ALERT SERVICE BULLETIN

210-23-17

MODEL AFFECTED: 210

SUBJECT: INBOARD STRAP FITTING 212-010-103-101,
RECALL OF

Figure 1. Inboard strap fitting 212-010-103-101.

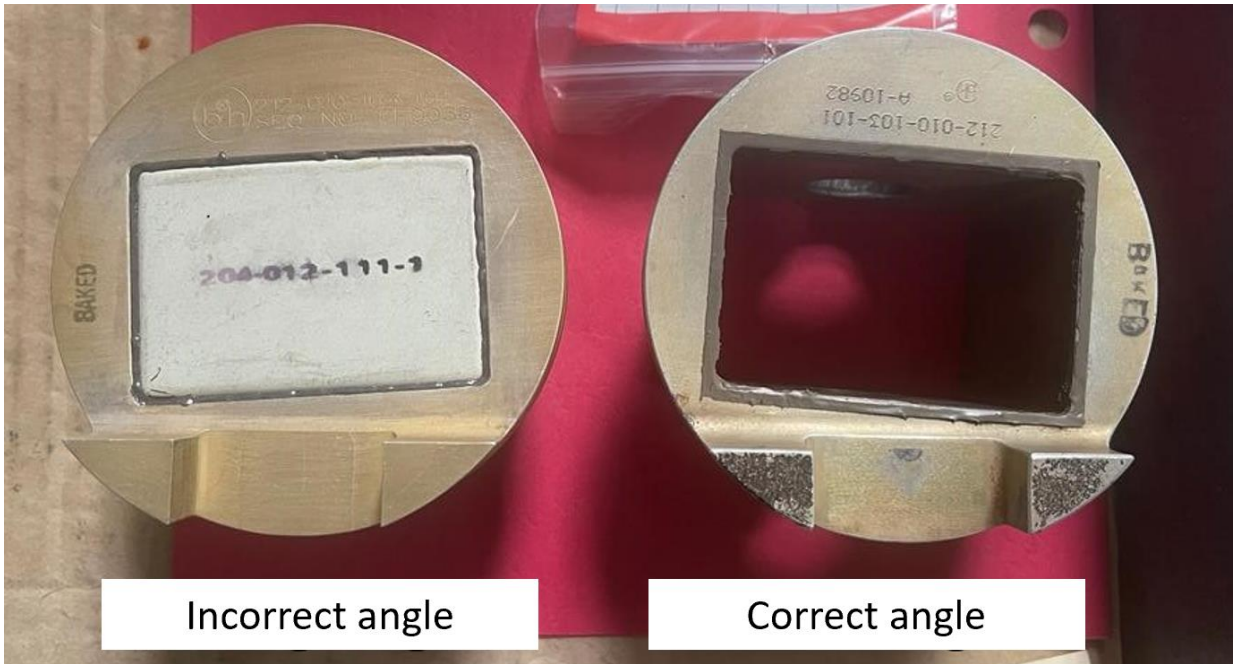
Bell has been informed that some 212-010-103-101 inboard fittings have been incorrectly manufactured with the static stop lugs at an incorrect angle as shown in Figure 1. This ASB requires that the affected fittings be returned to Bell. Applicability of this bulletin to any spare part shall be determined prior to its installation on an affected helicopter.

1. Review helicopter records and current spare inventory for inboard strap fittings 212-010-103-101 with a serial number ranging from FF0002 through FF0047 inclusively.
2. If affected strap fittings have been installed, replace in accordance with the BHT-212-CR&O chapter 62.
3. Return all defective inboard strap fittings to Bell using the instructions detailed in the WARRANTY section.
4. If an affected inboard strap fitting had to be removed from a main rotor hub assembly, make an entry in the helicopter logbook (if applicable) and historical service records indicating compliance with this Alert Service Bulletin.
